RECORD PLANS

PROPOSED IMPROVEMENT
 BRIDGE PROJECT

PROJECT NAME: MENDON
PROJECT NUMBER: BRO 1443(43)

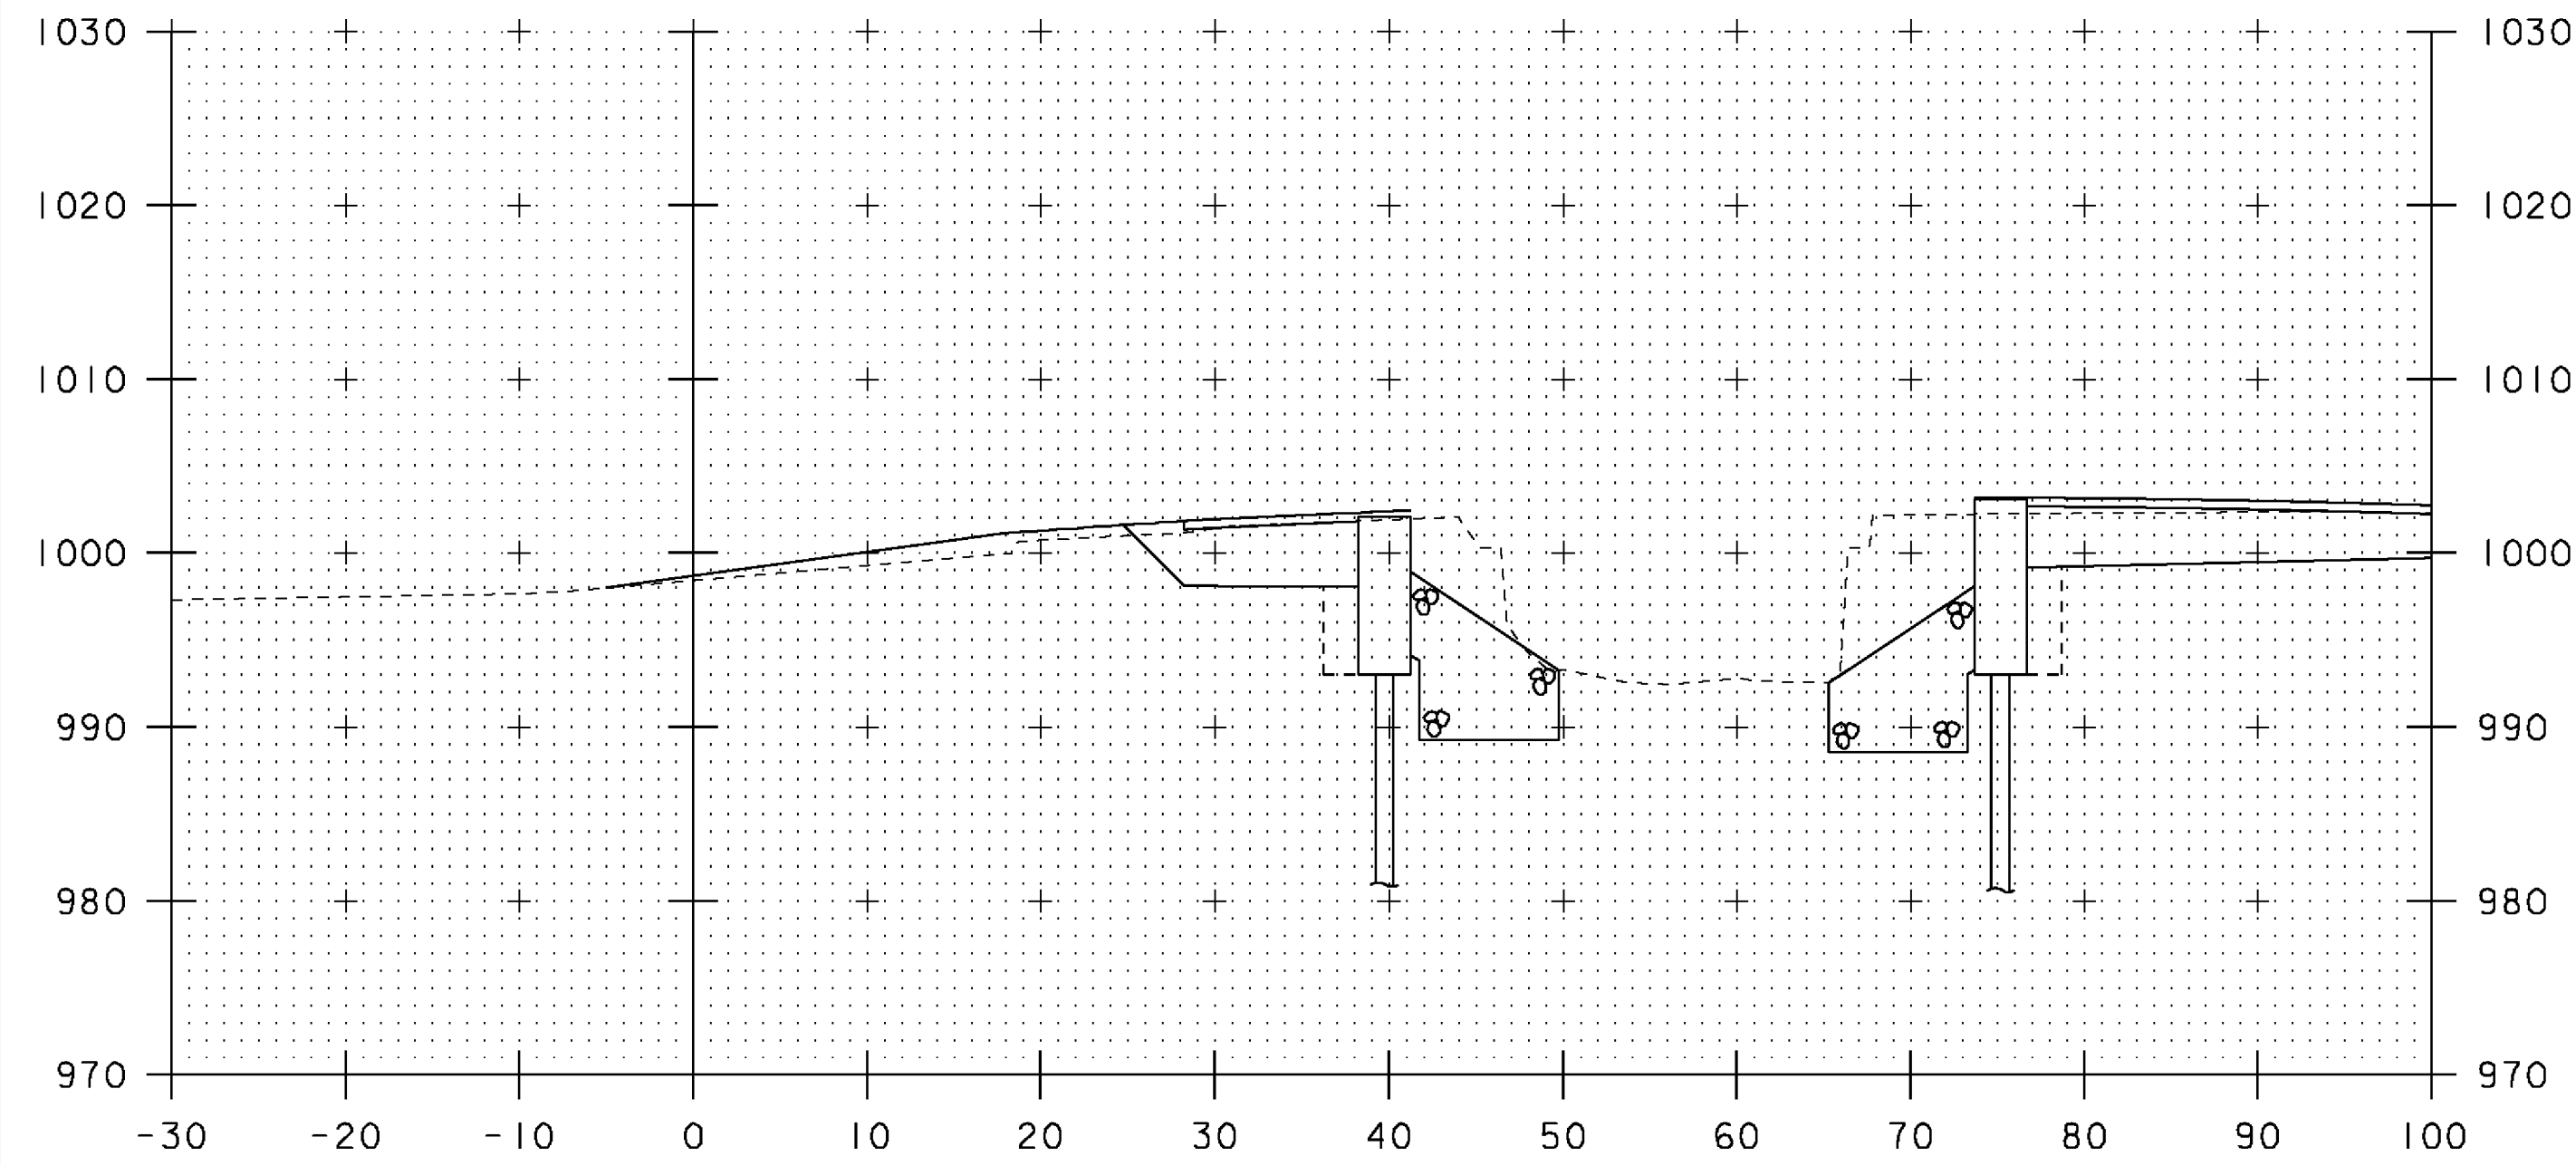
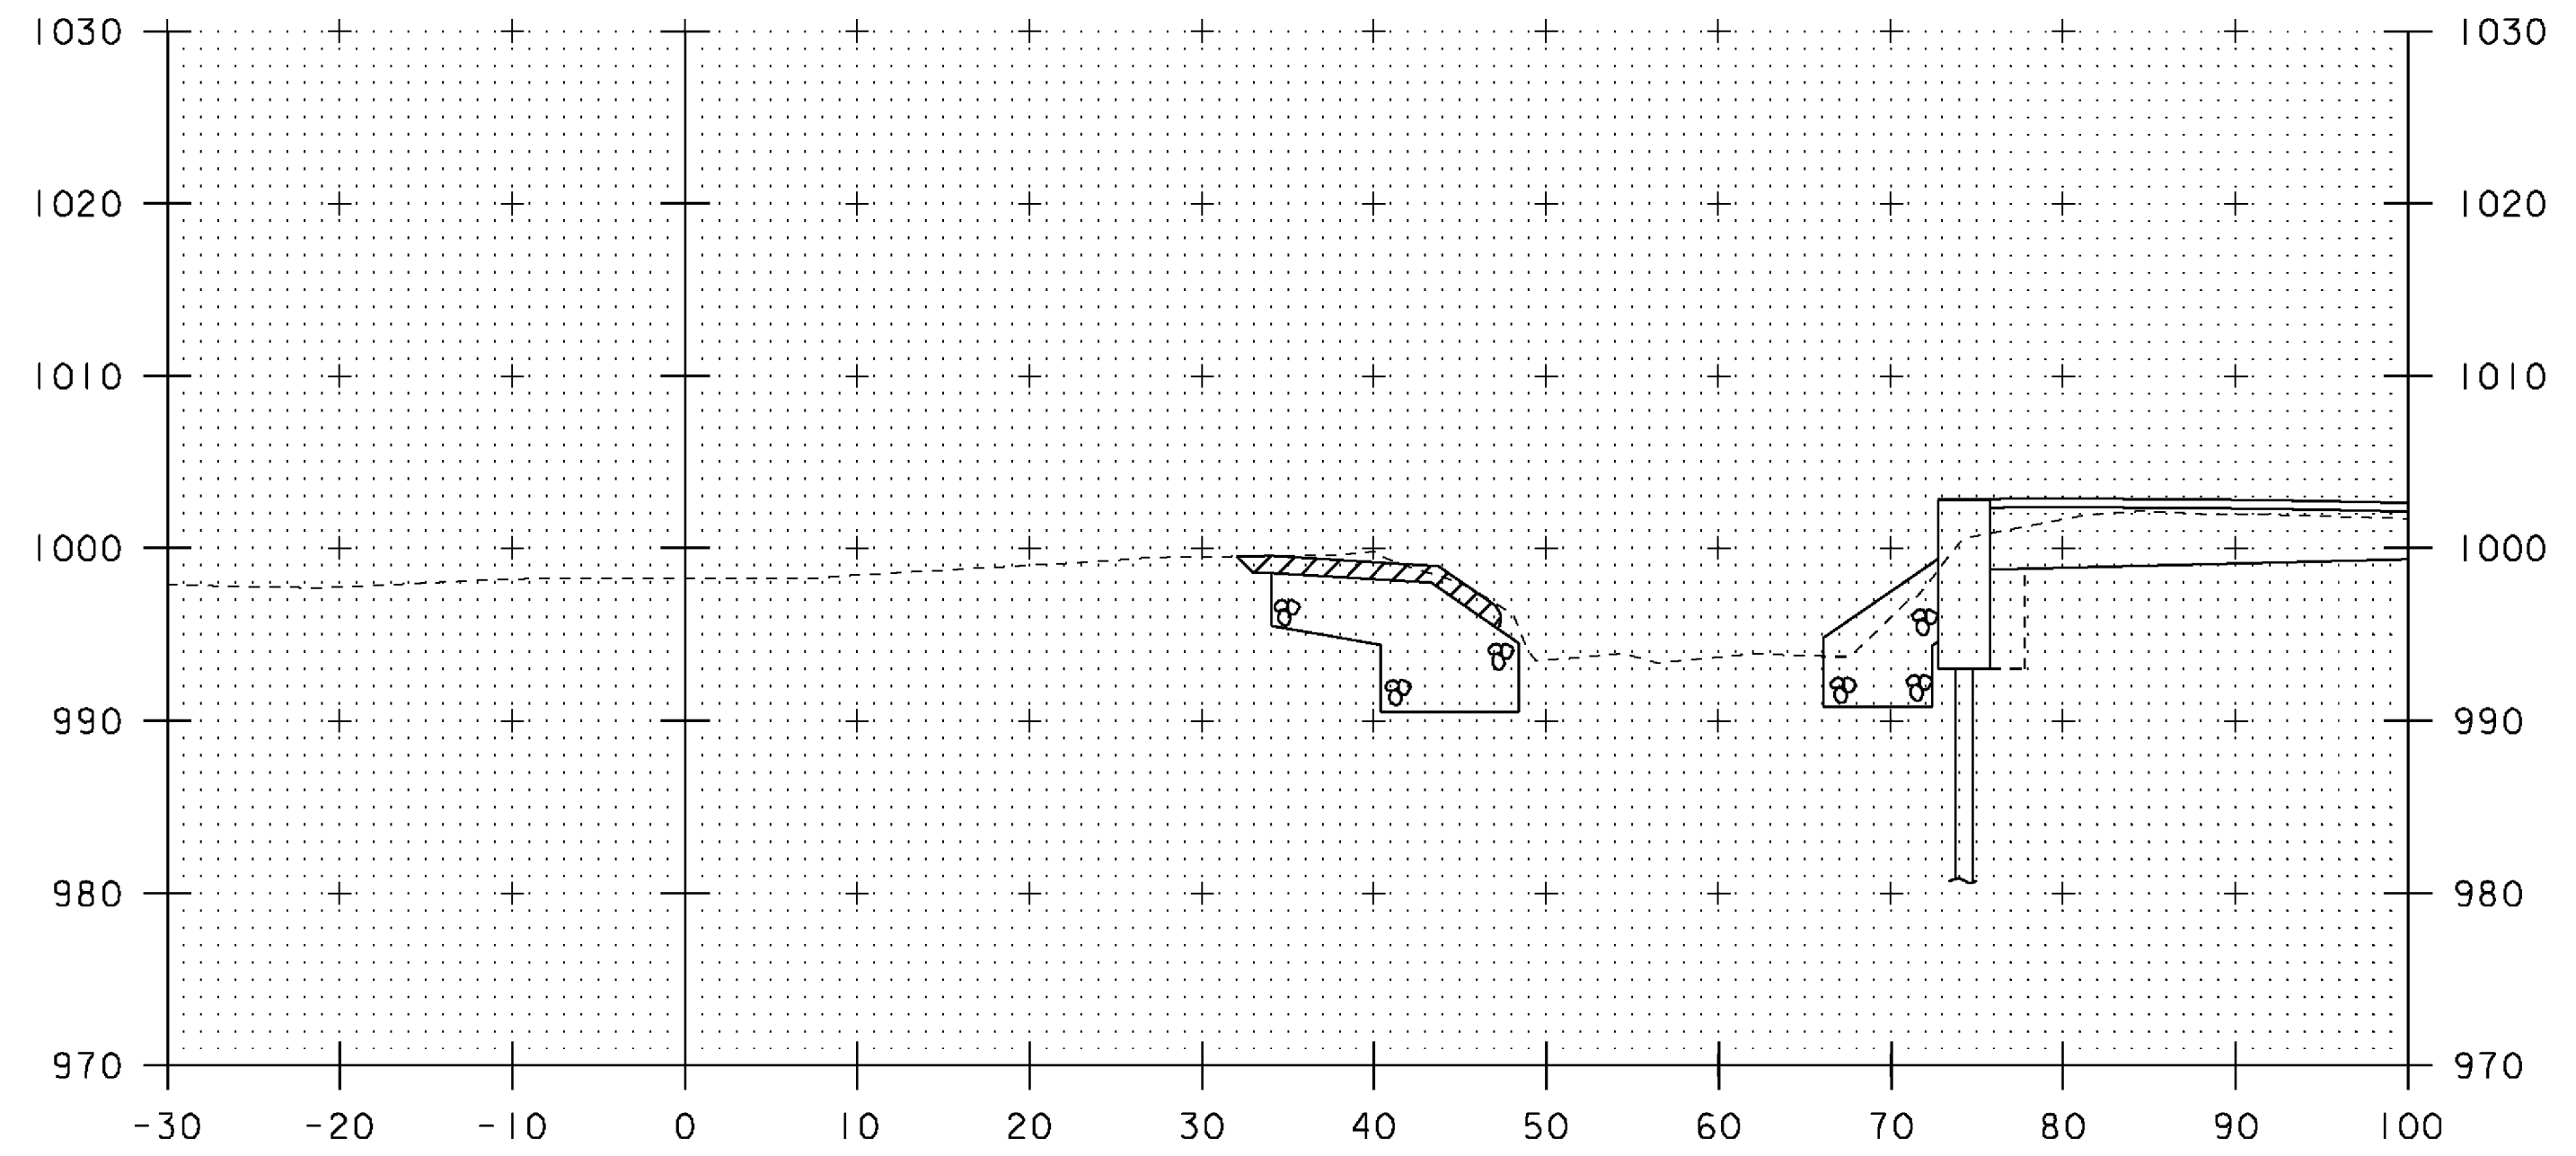
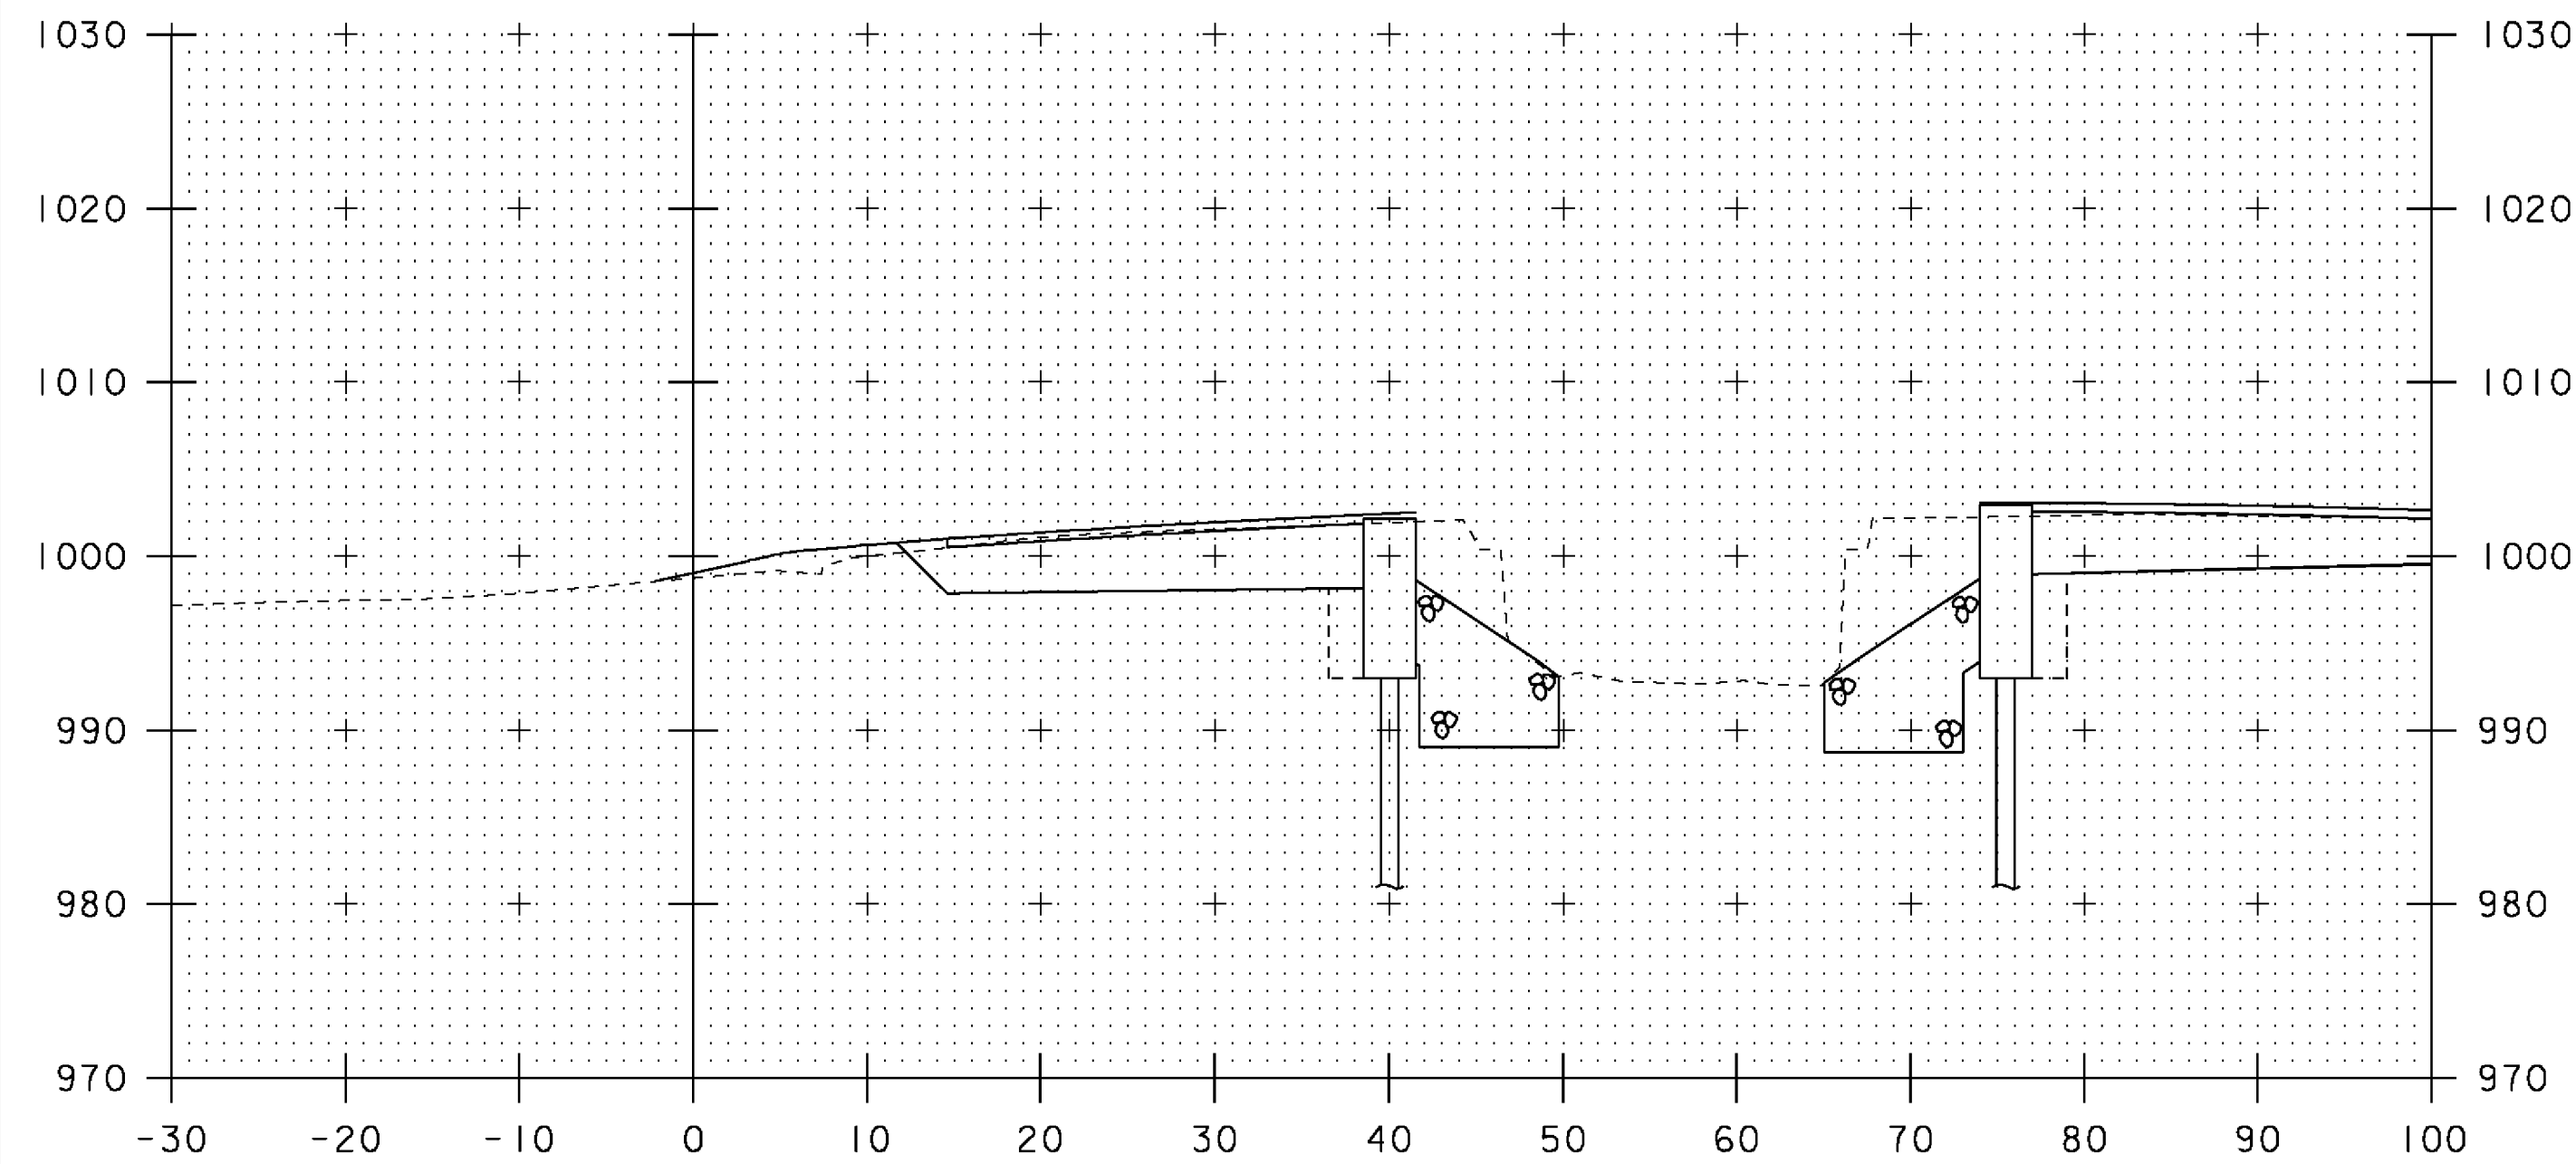
EXISTING GROUND NO LONGER VALID SINCE IRENE 8-28-II.
 NEW SURVEY REQUIRED FOR CHANNEL SECTIONS
 (TYP ALL SHEETS 31 & 32).
